Continental Airlines, Inc.
Systems Engineering
600 Jefferson Blvd
Houston, TX 77002

Subject: B757 Inspection of Wire Bundles in Wing AFT Fairing – Proposed Rule

Reference: A/ Rules Docket No. FAA-2004-19540
B/ Boeing Service Bulletins 757-28A0073 & 757-280074
C/ NPRM Docket No. 2004-NM-110-AD

FIGURE 2

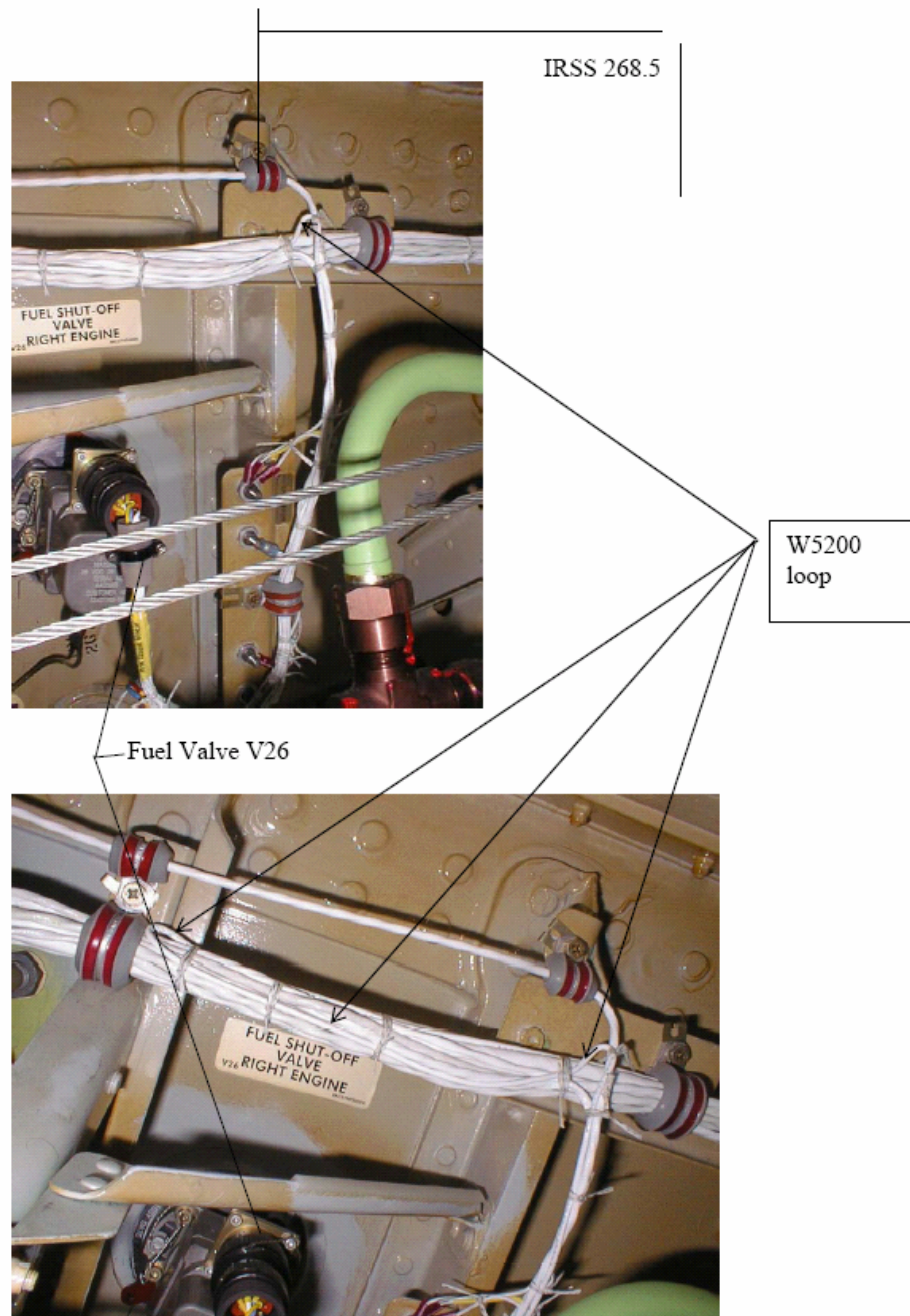
- The wiring for the right engine fuel shutoff valve in certain airplanes is found to be touching the hydraulic tubing and there is no provisioning to maintain proper separation. Refer to figure 2.

- Regarding the relocation of the wiring to clear the hydraulic tubing, the installation of a back to back and tube to wire clamps in order to maintain the proper wiring separation. Refer to figure 4.

FIGURE 3

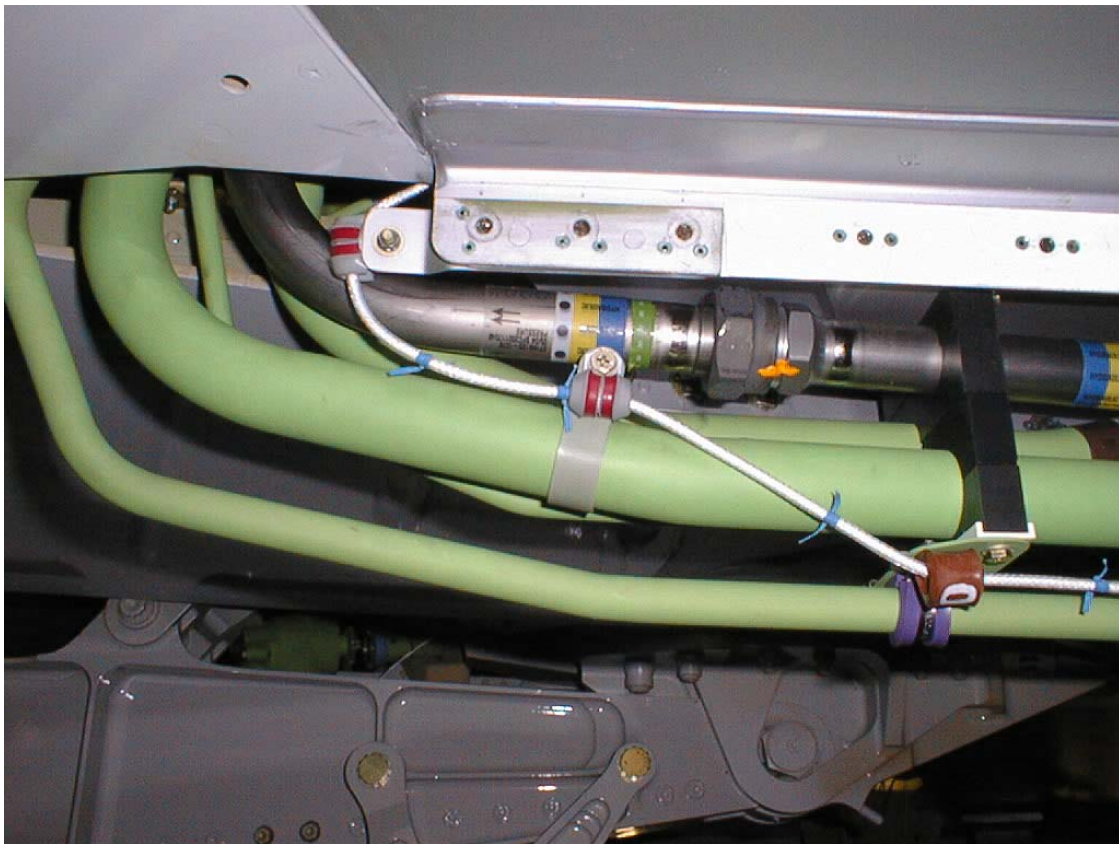
- Regarding the tight wiring discrepancy there are two possible solutions; a) to splice additional wire length per Standard Wiring Practices Manual, not a preferred solution due to location of the wire in a high vibration, flammable and environmental affected area and b) identification of any excess wiring near the end of the wire run at the shutoff valve, that is approximately 7 feet inboard along the rear spar at IRSS 270. Refer to figure 3.
